ARCHITECTURAL REVIEW BOARD MEETING

PROJECT NUMBER: SP2024-038
PROJECT NAME: Site Plan for Mt. Zion Meter Vault
SITE ADDRESS/LOCATIONS: 3275 N JOHN KING BLVD, ROCKWALL, TX 75032

08/23/2024: SP2024-038: Site Plan for a Municipally Controlled Utility Substation
Please address the following comments (M= Mandatory Comments; I = Informational Comments)

PROJECT NUMBER: SP2024-039
PROJECT NAME: Site Plan for Peachtree Meadows Amenity Center
SITE ADDRESS/LOCATIONS: 1400 CHASTAIN ST, ROCKWALL, TX 75032

MT. ZION METER VAULT SITE PLAN

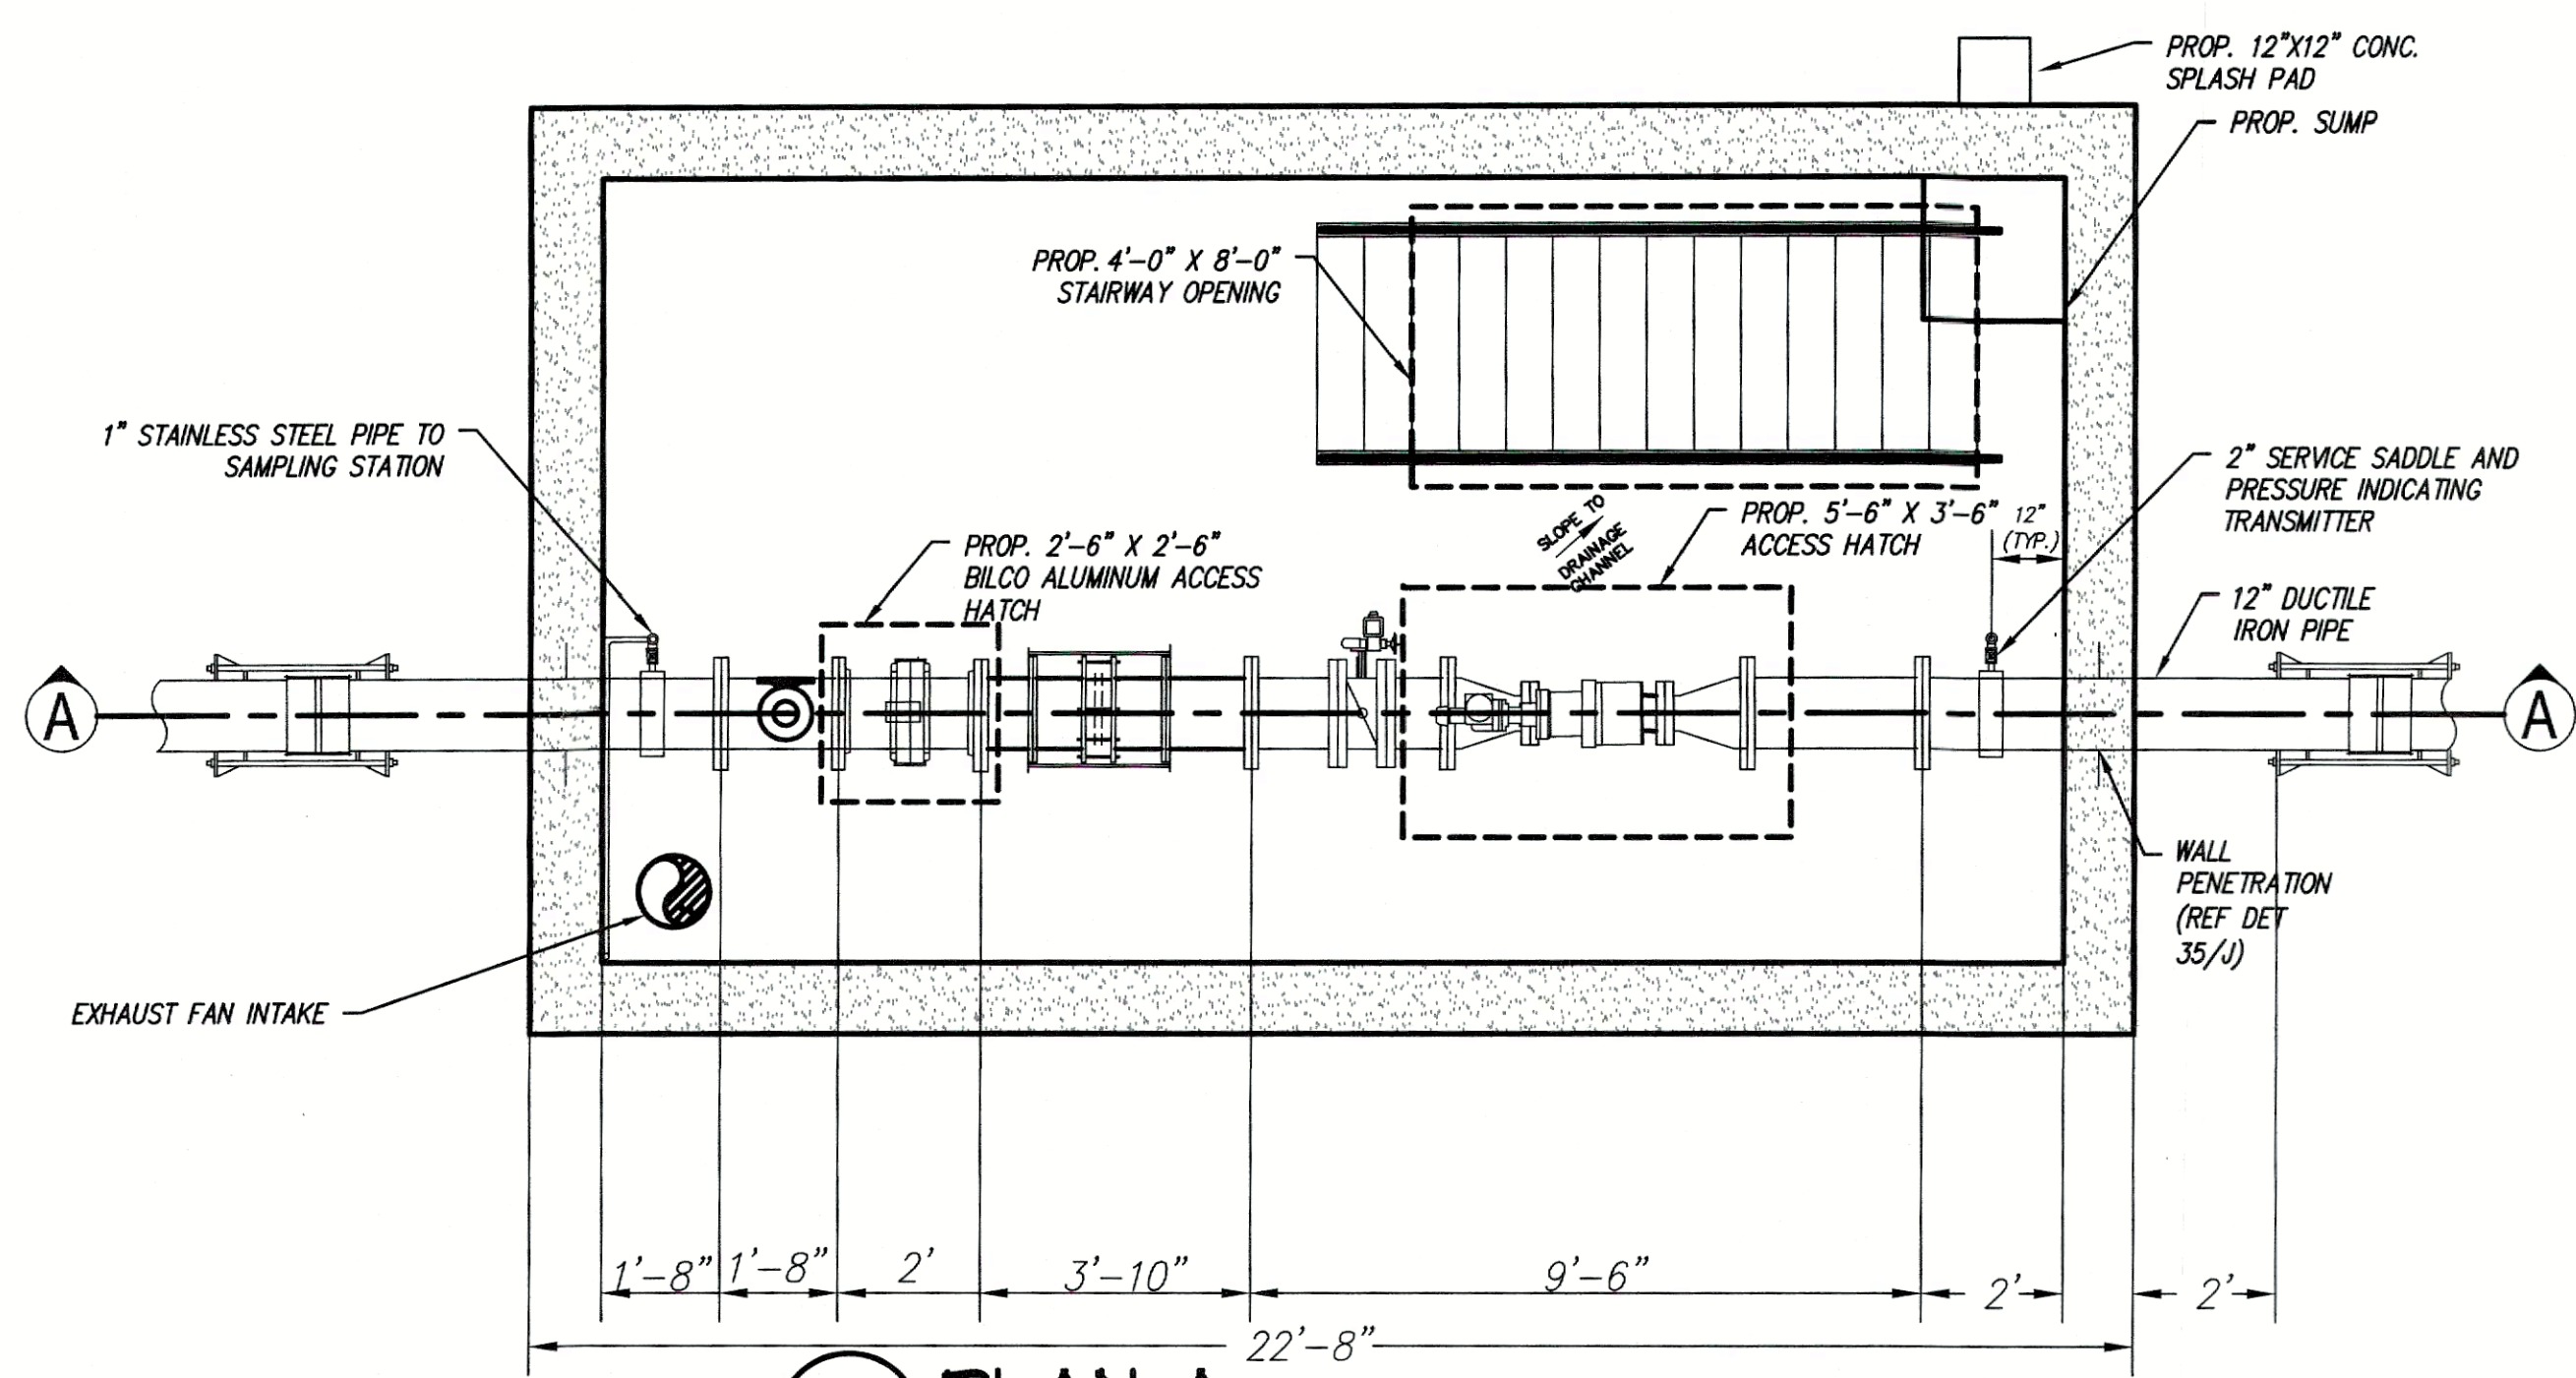
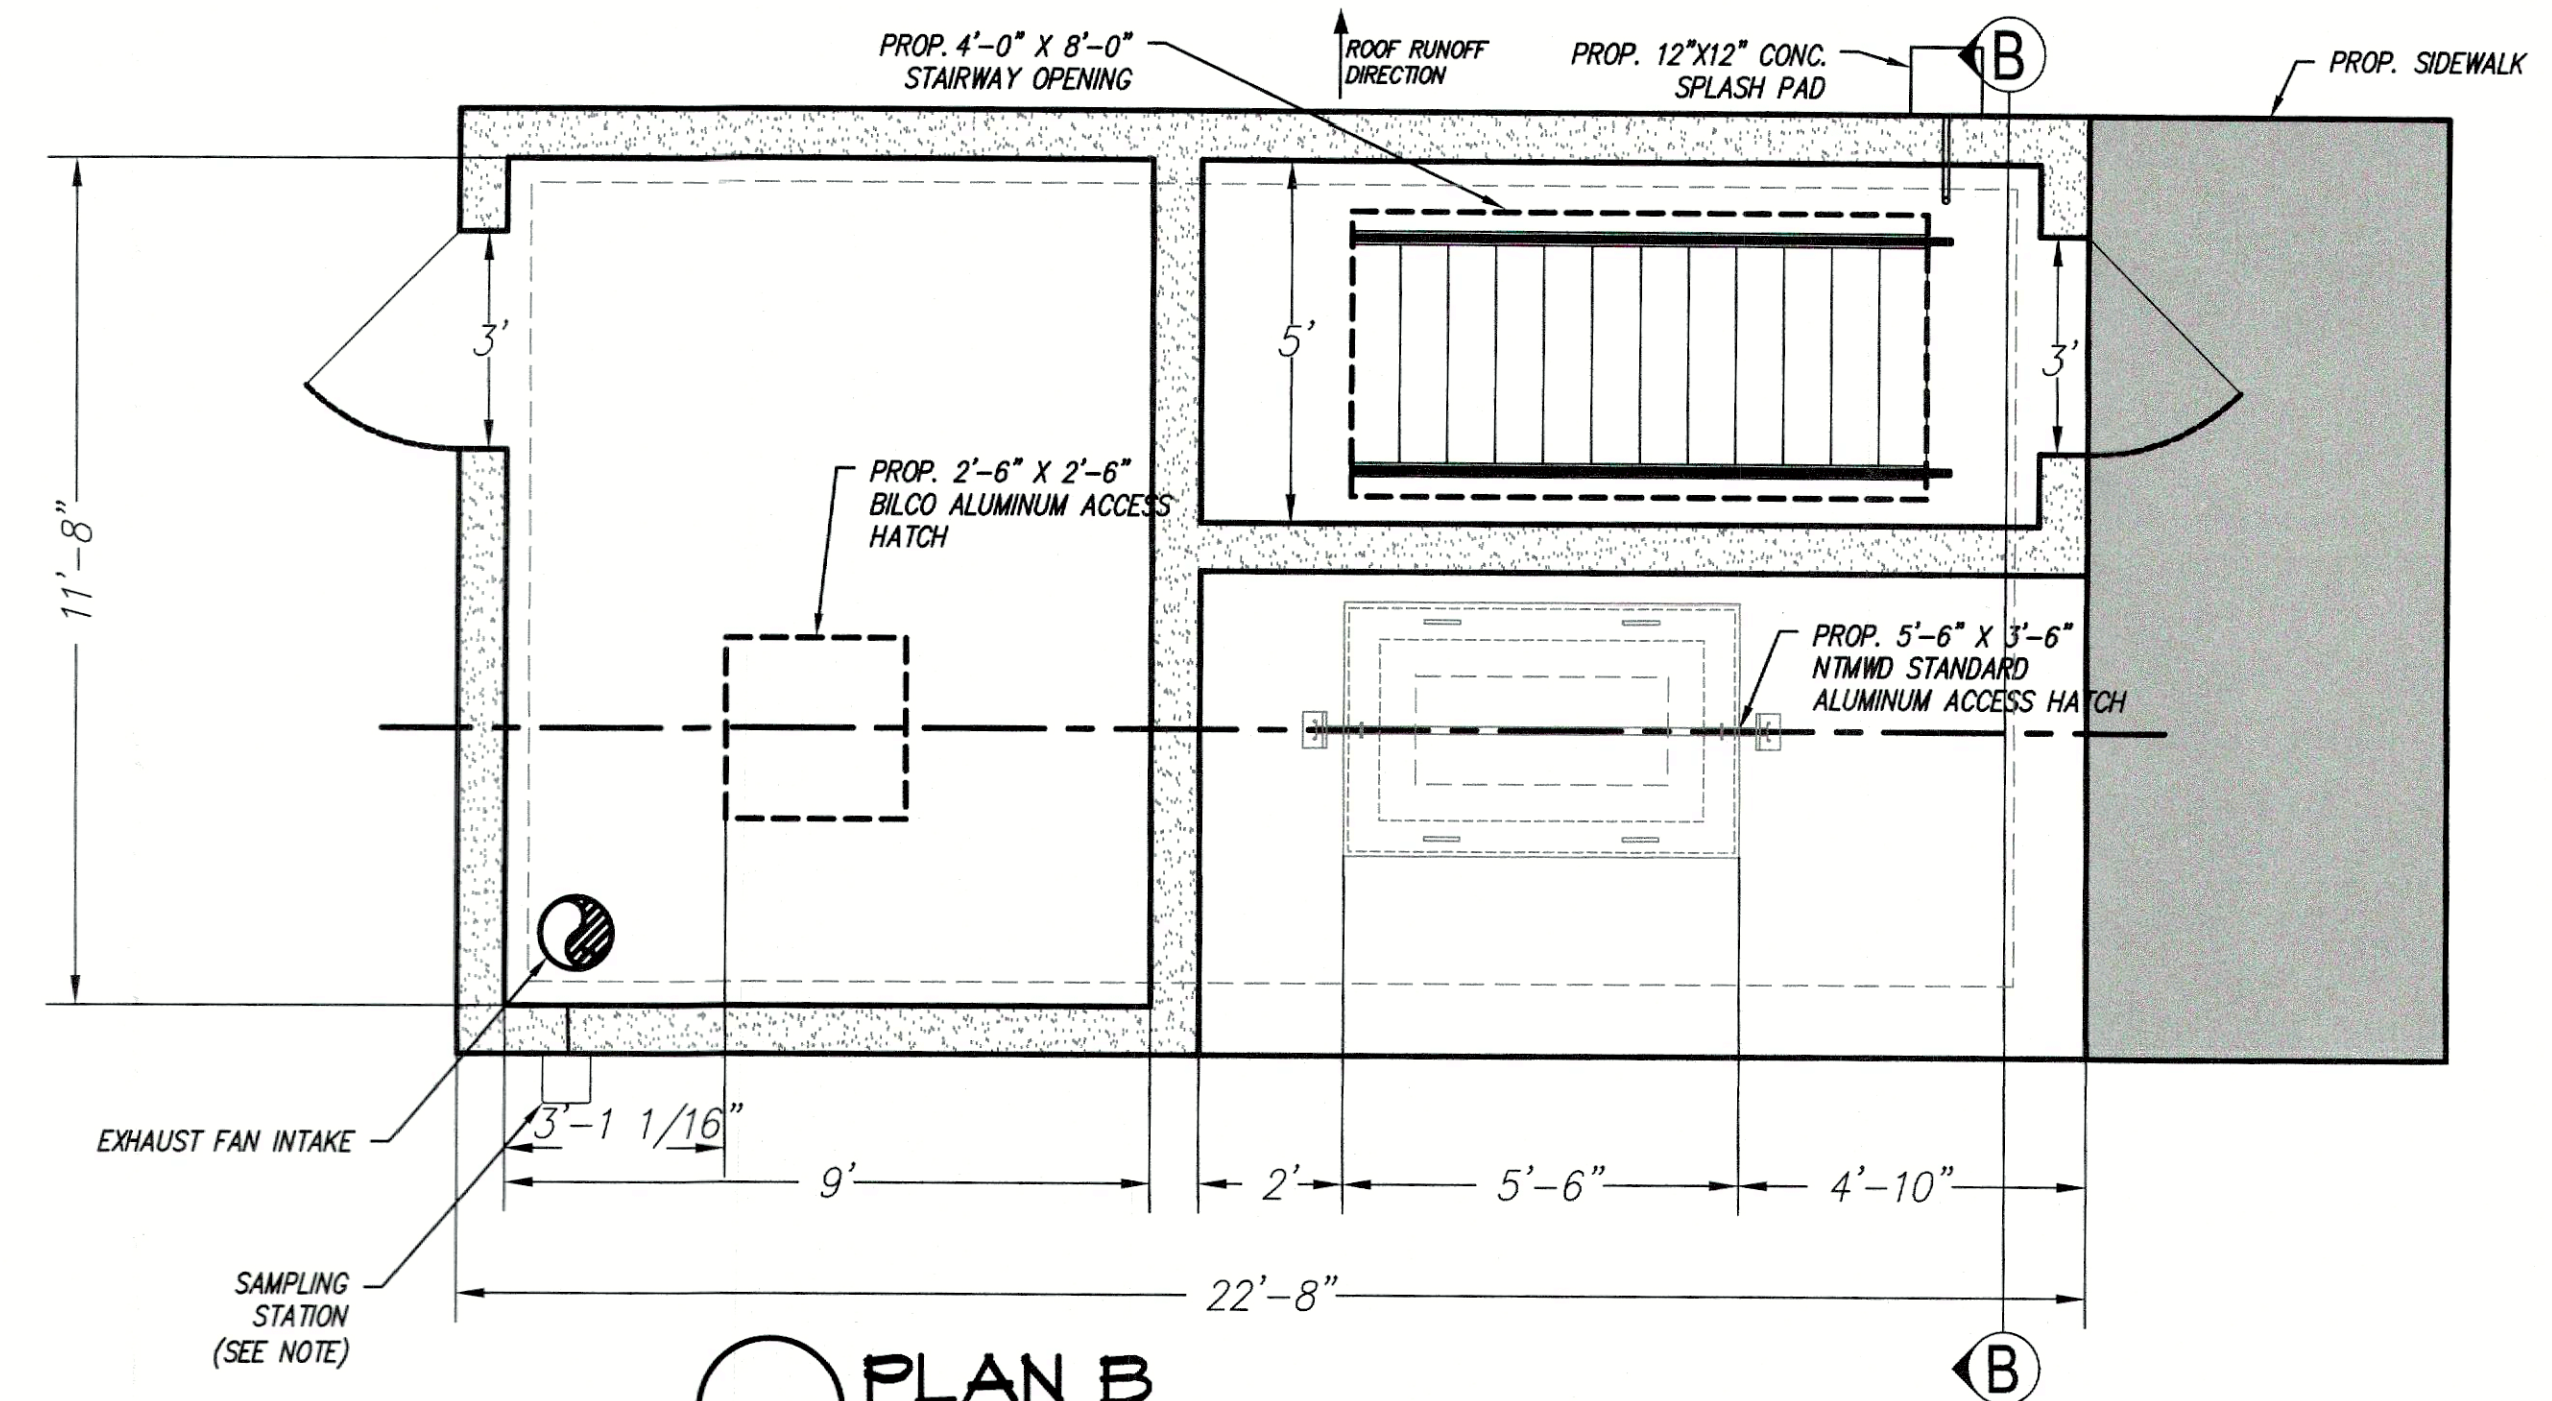
M.5 Site Plan

(1) The PD ordinance calls for a minimum masonry requirement of 90% on the exterior façades of all building. Masonry allowed shall be full width brick, natural stone, and cast stone only. In this case, the applicant is requesting to construct using CMU's. This will require a variance from the Planning and Zoning Commission. (PD-80; Ordinance No. 16-

- (2) The site plan indicates a 30-foot antenna tower. Please provide elevations for this and for the screening required on any equipment associated with the tower. Please note that ice bridges are not permitted. (Subsection 03.03, Article 04, UDC)
- (3) The proposed swing metal gates and proposed fence shall be wrought iron. Please provide a detail of each. (PD-80; Ordinance No. 16-08)
- (4) Please provide a vicinity map as a reference for the subject property location. (Subsection 03.04 A, of Article 11, UDC)
- (5) Please indicate the dimensions of the parking spacing. The minimum is 9'x20'. (Engineering Standards of Design and Construction)
- (6) The applicant will be required to plat the plat prior to the issuance of a Building Permit.
